802.3dj D2.0

Comment Resolution

Common Track

Proposed generalized figure for MAC-to-MAC path

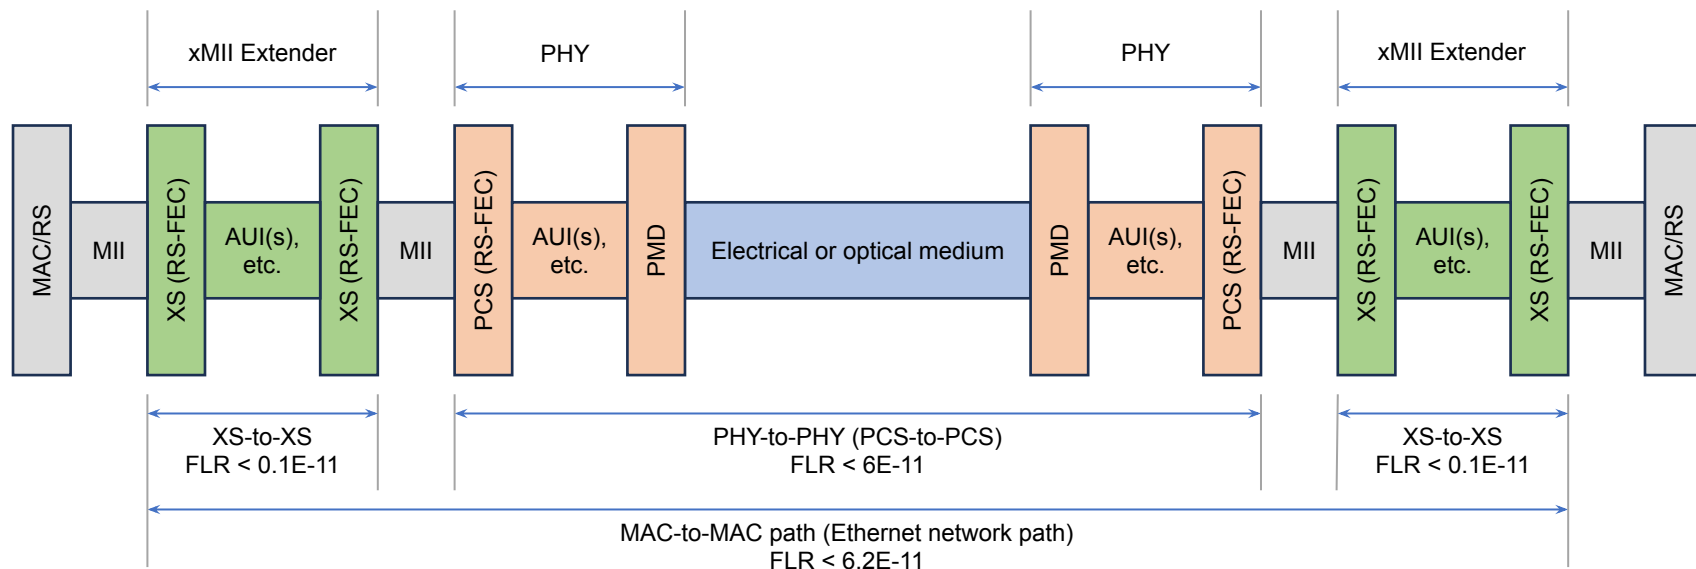
Diagrams showing the various paths or domains described in 174A.3 through 174A.7 would be very helpful to the reader of the annex.

Add a diagrams illustrating the paths described in 174A.3 through 174A.7.

A figure will make this much more clear

Add a figure to show the link in 174A.5, 174A.6 and 174A.7

#292 and #106 propose adding figures to help understand the context for each of the error ratio allocations.

PROPOSED ACCEPT.

PROPOSED ACCEPT IN PRINCIPLE.
Resolve using the response to comment #292.

PROPOSED ACCEPT IN PRINCIPLE.
Ultimate the path is from MAC to MAC. Also, RS can easily be misinterpreted as meaning RS-FEC.
Change "network path" to MAC-to-MAC path.

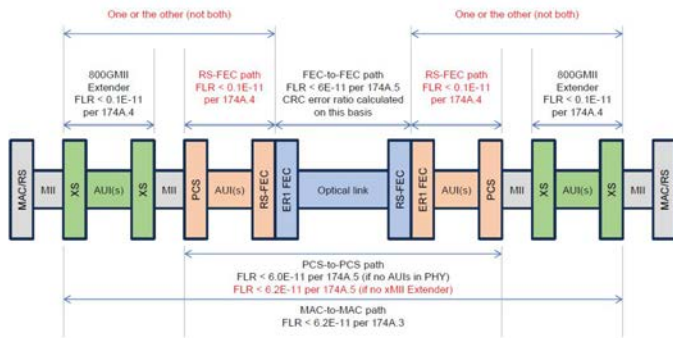
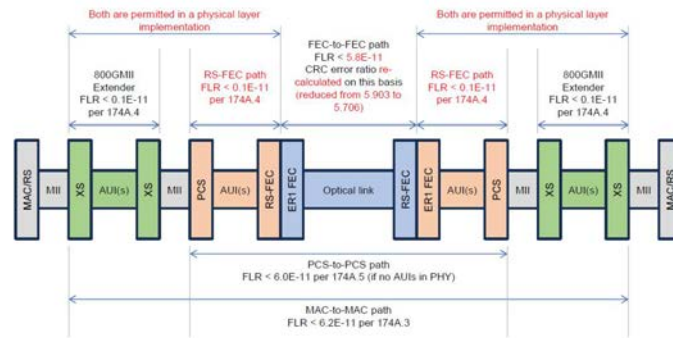
For 800GBASE-ER1/ER1-20...

Option #2 (above) was adopted in Draft 1.5.

D2.0 comment #xxx proposes to adopt option # (right)

Proposed figure for optical PHY types

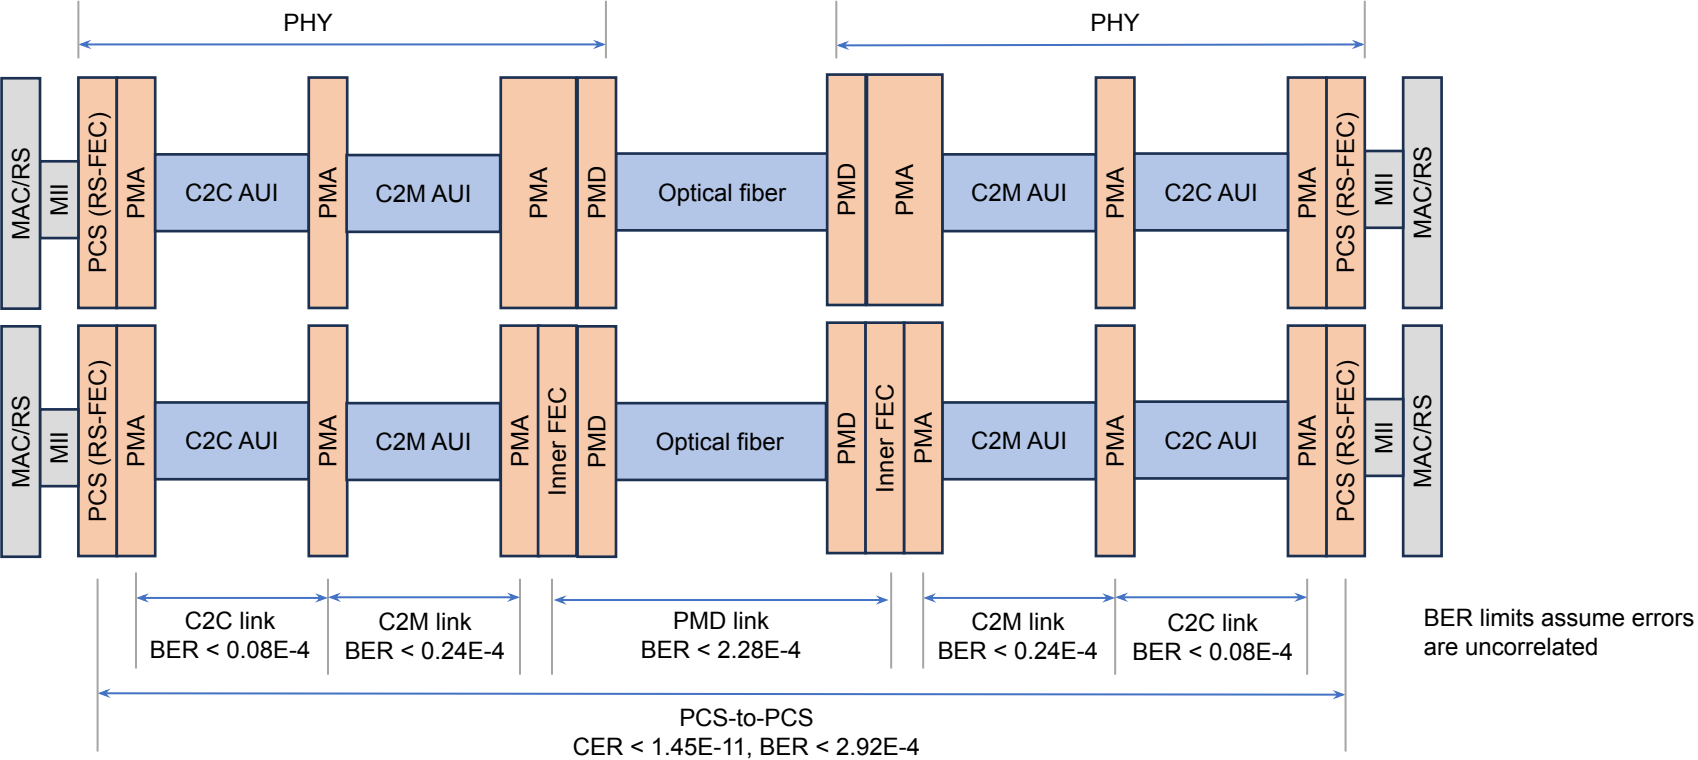
Cl 174A	SC 174A.6	P 678	L 28	# 585
Nicholl, Gary		Cisco Systems		
Comment Type	TR	Comment Status	D	(Common) FLR allocation
FLR allocation for 800GBASE-ER1/ER1-20.				
During the March plenary the consensus was to adopt option# 2 of https://www.ieee802.org/3/dj/public/25_03/brown_3dj_04a_2503.pdf , for the FLR allocation for 800GBASE-ER1/ER1-20.				
Also, see the final response to comment #16 in https://www.ieee802.org/3/dj/comments/D1p4/8023dj_D1p4_comments_final_clause.pdf .				
An implication of this decision is that 800GBASE-ER1/ER1-20 PHYs are different from other 802.3dj PHYs, in that you are only allowed to have AUIs in the PHY or Extender, but not both (see slide 18 of brown_3dj_04a_2503). For other 802.3dj PHYs you are allowed to have AUIs in both the PHY and the Extender.				
This means it is possible to have a host design that contains two AUIs (one in an Extender and one in the PHY) that would not support an 800GBASE-ER1/ER1-20 PHY, but would support all other 802.3dj PHYs.

I don't think that an 800GBASE-ER1/ER1-20 PHY should be treated as a special case.				
I propose changing the FLR allocation for the 800GBASE-ER1/ER1-20 PHY to be consistent with all other 802.3dj PHYs, such that there are no restriction on which hosts an 800GBASE-ER1/ER1-20 PHY can be deployed in.				
This is essentially option #3 in brown_3dj_04a_2503, where the FLR of a 800GBASE-ER1/ER1-20 PHY, with or without an AUI, is defined as 6 x 10 ⁻¹¹ (consistent with all other 802.3dj PHYs). This in turn means reducing the FLR for the ER1-to-ER1 FEC link from 6 x 10 ⁻¹¹ to 5.8 x 10 ⁻¹¹ .				
<i>Suggested Remedy</i>				
Change the FLR allocation for 800GBASE-ER1/ER1-20 to implement option #3 in https://www.ieee802.org/3/dj/public/25_03/brown_3dj_04a_2503.pdf .				
Make the necessary changes in clauses 187 and 174A.				
A supporting presentation will be provided.				
Proposed Response		Response Status	W

Comment #585 proposes to change the FLR budgeting for 800GBASE-LR1. The appropriate diagram can be used once that decision is made. Shown here for reference.

PROPOSED REJECT.				
The comment proposes to change a decision made by the CRG as detailed in the comment. However, the comment makes a good case and a proposal is forthcoming.				
Pending task force review of the supporting contribution.

Figure 178B-8—Training control state diagram

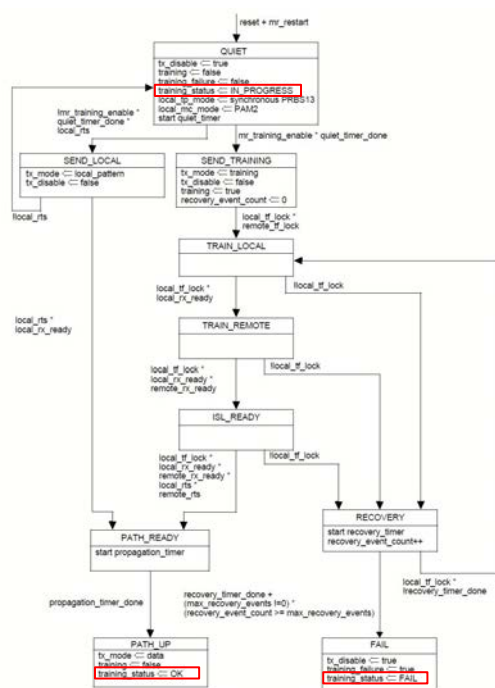
Training status can not be both a AUI component variable and a per-lane training variable.
Local_rts is an equivalent status to it and is mapped to a MDIO register bit.

Move the definition of training_status to 178B.14.3.1
Remove the enumeration of "READY" from its definition.
Delete training_status <= READY from Figure 178B-7

The variable training_status is used by the 'Training control state diagram' in subclause 178B.14.3.5 'State diagram figures' but is not defined in the associated subclause 178B.14.3.1 'Variables'.

In addition, it appears that the training_status is a per-interface variable based on the definition found in 178B.14.2.1 'Variables', yet it appears to be driven by both the per-interface 'RTS update state diagram' (Figure 178B-7) and the per-lane 'Training control state diagram' (Figure 178B-8). I'm not sure how this would operate.

As an example, if the Training control state diagram on one lane in an interface enters the FAIL state, it would set training_status for the interface to FAIL. If, however, the Training control state diagram on another lane in the same interface enters the PATH_UP state immediately afterwards, training_status for the interface would then be set to OK. This doesn't seem to be correct.

training_status is defined as a per-interface variable (in 178B.14.2.1), but it appears in both per-lane and per-interface state diagrams. Formally there needs to be more than one variable.

PROPOSED ACCEPT IN PRINCIPLE.
training_status is used by the PMDs and AUIs (see 178.4, 179.4, 180.3, 181.3, 182.3, 183.3, 176C.6 and 176D.4) so it shall be assigned a value by ILT.
It is a per-interface variable that is assigned to all lanes of the interface.
Define a new variable in 178B.14.3.1: lane_training_status. Defined as: Enumerated variable that indicates the status of the per-lane ILT function. This variable may be assigned one of the following values: IN_PROGRESS, OK, FAIL.
Use this new variable in the per-lane state diagrams instead of training_status.
Change the definition of the variable training_status to: Enumerated variable that indicates the status of the per-interface ILT function. This variable may be assigned one of the following values: IN_PROGRESS, READY, OK, FAIL. The value READY is assigned by the RTS update state diagram (Figure 178B-8) and other values are assigned according to the lane_training_status variable (see 178B.14.3.1):

IN_PROGRESS - lane_training_status variable = IN_PROGRESS for any lane assigned to the interface
OK - lane_training_status variable = OK for all lanes assigned to the interface
FAIL - lane_training_status variable = FAIL for any lane assigned to the interface
Implement with editorial license.

Define a new variable in 178B.14.3.1 (Per-lane variables): lane_training_status

Enumerated variable that indicates the status of the training control state diagram. This variable may be assigned one of the following values: IN_PROGRESS, OK, FAIL.

Use this new variable in the per-lane state diagrams instead of training_status.

Figure 178B-7—RTS update state diagram

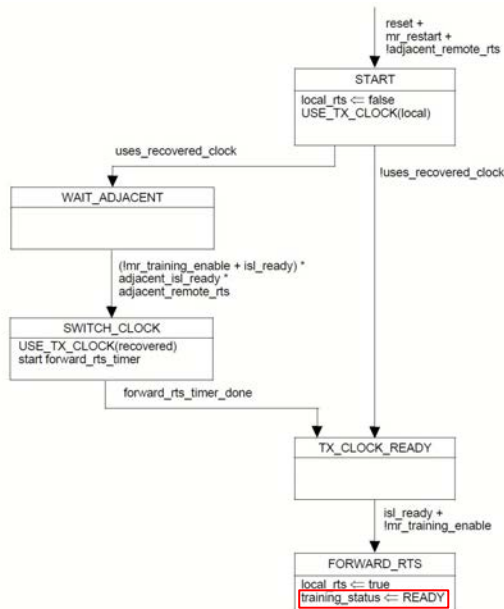
Note that the value READY is assigned only be the per-interface state diagram; READY is equivalent to (all lanes are IN_PROGRESS) and (local_rts is true).

Option B: delete its assignment from the per-interface state diagram (Figure 178B-8), making it a non-state-diagram variable, and use the following definition:

Enumerated variable that indicates the status of the ILT function. This variable may be assigned one of the following values: IN_PROGRESS, READY, OK, FAIL. Assignment to this variable occurs both by the RTS update state diagram (Figure 178B-8) and by changes to the lane_training_status variables of the lanes in the interface, as follows:

- = IN_PROGRESS: assigned when lane_training_status = IN_PROGRESS on all lanes.
- = READY: assigned by the RTS update state diagram.
- = OK: assigned when lane_training_status variable = OK on all lanes
- = FAIL: assigned with lane_training_status variable = FAIL on any lane

Enumerated variable that indicates the status of the ILT function. This variable may be assigned one of the following values: IN_PROGRESS, READY, OK, FAIL. This variable is assigned as follows:

- = IN_PROGRESS: if lane_training_status = IN_PROGRESS on all lanes and local_rts = false
- = READY: if lane_training_status = IN_PROGRESS on all lanes and local_rts = true
- = OK: if lane_training_status = OK on all lanes
- = FAIL: if lane_training_status = FAIL on any lane

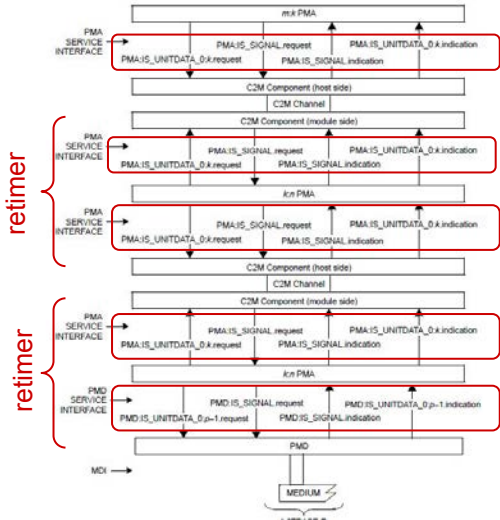
This is not very clear. I would suggest adding the definition of "adjacent service interface" in subclause 178B.3.

SuggestedRemedy
 I would suggest adding the definition of "adjacent service interface" to subclause 178B.3 and referencing a diagram, like the one on Slide 3 of "Making Sense out of ILT" (J. D'Ambrosia, M. Brown, 802.3dj Joint Ad hoc Mtg - 05 Jun 2025).

The second case in the NOTE says: "For ILT in an AUI component above a PMA, the adjacent service interface is the interface below the AUI component". That is the PMA's service interface. It may be easier to understand if it is stated.
 Also, a figure illustrating the two cases would be helpful.

SuggestedRemedy
 Change "the adjacent service interface is the interface below the AUI component" to "the adjacent service interface is the PMA service interface (below the AUI component)".
 Add a figure, with editorial license.

There is only one service interface on an AUI component or PMD, so it is not necessary to qualify it with the word "adjacent".

In fact, the word adjacent is used to reference the AUI component or PMD on the other side of a retimer.

Change the note in 178B.14.2.1 to:

NOTE — For a PMD or an AUI component below a PMA, SIGNAL_OK is received via the IS_SIGNAL.request primitive of the service interface above the PMD or AUI component. For an AUI component above a PMA, the SIGNAL_OK is received via the IS_SIGNAL.indication primitive of the service interface below the AUI component.

Change other references of "adjacent service interface" to "service interface".

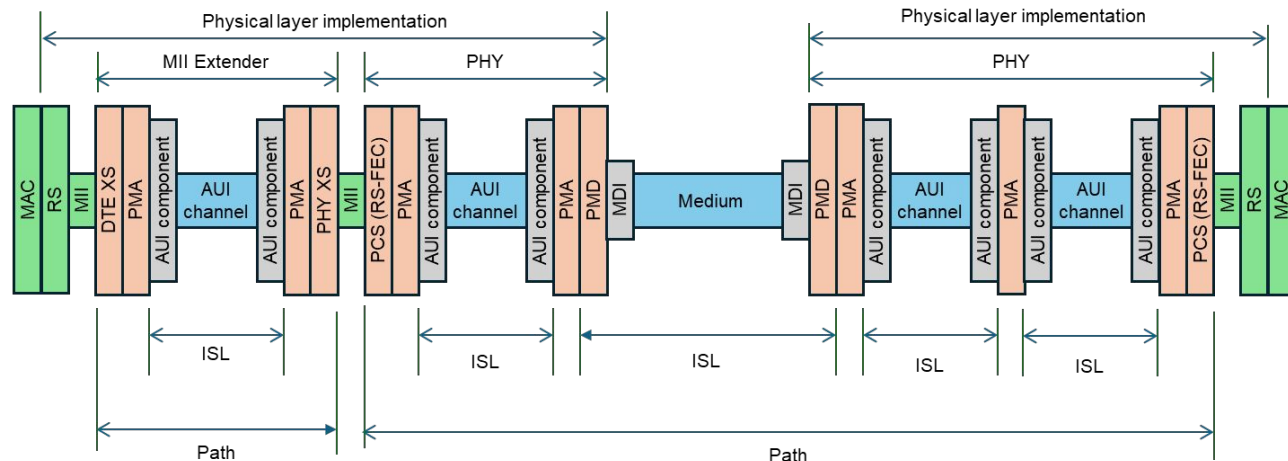
Given the introduction of inter-sublayer link training to the Ethernet world, it would be helpful if the term inter-sublayer link (ISL) was displayed graphically for the reader.

Implement figure on Page 3 of
https://www.ieee802.org/3/dj/public/adhoc/electrical/25_0605/dambrosia_3dj_elec_02_250605.pdf with editorial license

However, this slide provides an figure, update since presented to the ad hoc.

This diagram is provided as a reference for discussion and as a proposed diagram to add into Annex 178B.

As shown, the diagram includes two path types: XS-to-XS in an xMII extender and PCS-to-PCS across a pair of PHYs and the medium between.

178B.5.3 Training xMII Extenders

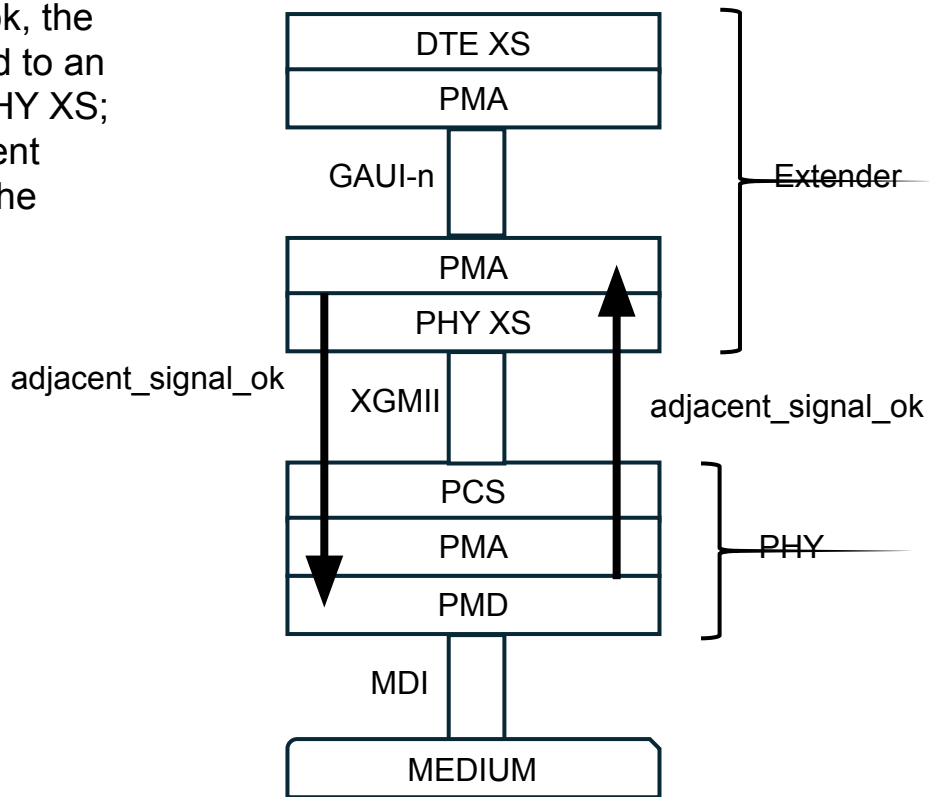
The text about training xMII extenders does not address the communication of the status variables `isl_ready` and `remote_rts` between interfaces (PMD to AUI and vice versa) when there is a PHY XS and PCS between them.

Ideally, this communication should be the same as the one defined in 178B.14.2.1 using `adjacent_signal_ok`, but the case of an extender is not covered by NOTE that describes what "adjacent" is.

Since this behavior is specific to PHYs attached to extenders, it should be specified in this subclause, preferably with a diagram.

Add a figure to illustrate the communication of `adjacent_signal_ok` between the PMD and the AUI (across the PCS and PHY XS, and possibly other sublayers).

PROPOSED ACCEPT IN PRINCIPLE.
Implement suggested remedy with editorial license.

NOTE – For the purpose of adjacent_signal_ok, the adjacent interface of a PMD in a PHY attached to an xMII extender is the service interface of the PHY XS; and the adjacent interface of the AUl component above the PHY XS is the service interface of the PMD.

- ILT is done separately on extenders, and RTS is not communicated to the RS-to-RS link – such that extenders create separate paths
- As can be interpreted from D2.0 text

- Either Option 1 or Option 2 is allowed (left open for implementation)
